UNITED STATES  
NUCLEAR REGULATORY COMMISSION  
OFFICE OF NUCLEAR REACTOR REGULATION  
WASHINGTON, DC 20555-0001

NRC INFORMATION NOTICE 2017-05: POTENTIAL BINDING OF SCHNEIDER  
ELECTRIC/SQUARE-D MASTERPACT NT AND  
NW 480-VAC CIRCUIT BREAKER ANTI-PUMP  
FEATURE

**Figure 1 The XF coil in the original logic is replaced by an XFCOM coil, which releases the close coil plunger as soon as the close signal is received, eliminating the potential for binding**

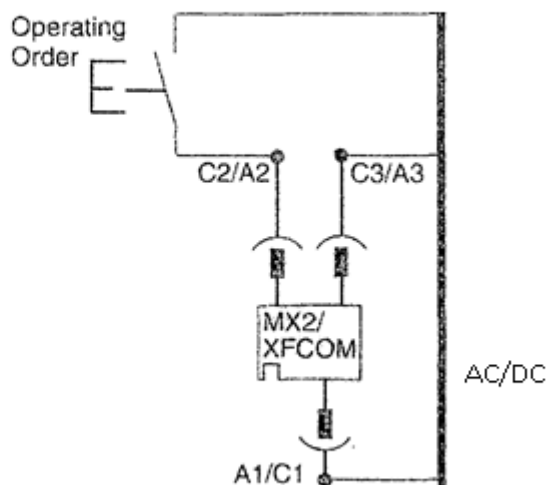
In Technical Bulletin TB-12-007, Revision 3, which is attached to the referenced 10 CFR Part 21 report (ADAMS Accession No. ML16278A471), AZZ/NLI provided a proposed modification to the breaker and an updated circuit diagram, shown in Figure 1. This modification replaces the normal XF coil in the breaker with an XFCOM coil. The XFCOM coil acts as a oneshot and releases the close coil plunger immediately after the close signal is applied to the breaker and will not reactivate the close coil plunger unless power is first removed from the operating order signal of the XFCOM and then re-applied. With the closing coil plunger retracted, this modification is designed to eliminate the potential for mechanical binding from the anti-pump feature.
